# **Bell Helicopter** **TEXTRON**

## **INFORMATION LETTER 407-05-87**

**SUBJECT: FILTER 50-075-1, INSPECTION AND RECALL OF**

Figure 1. Filter 50-075-1 Physical Difference

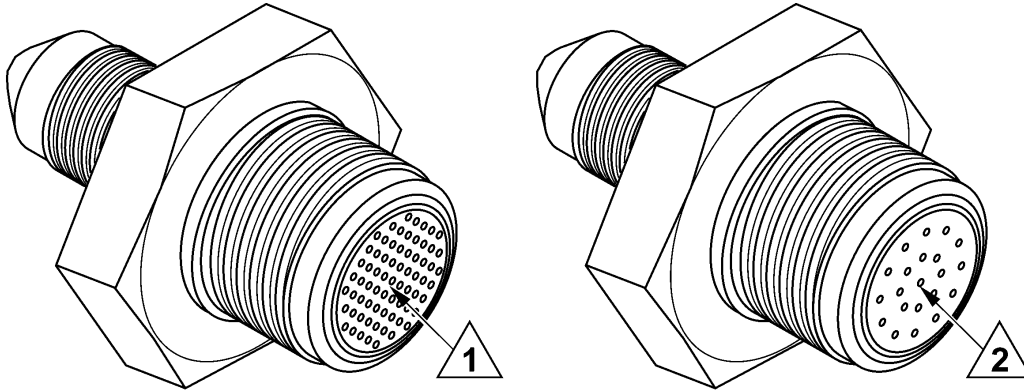
This information letter is issued to report that in some filter units 50-075-1, the screen portion of the filter was not manufactured with the correct number of holes. Testing has confirmed this condition is not detrimental to the normal operation of the transmission and freewheel oil system. However, Bell Helicopter recommends that filter units with an incorrect hole pattern be identified and replaced.

To identify the configuration to be removed from service, examine the screen hole pattern (refer to Figure 1). Replace any unacceptable filter unit at your earliest convenience.

- 1** Acceptable hole pattern. A minimum of 65 holes are required.
- 2** Unacceptable hole pattern to be removed from service.

Bell Helicopter will supply parts necessary to perform this task, consisting of packing M83248/1-906 and filter 50-075-1, at no charge. This credit is available for non-compliant filters that are installed or in stock.
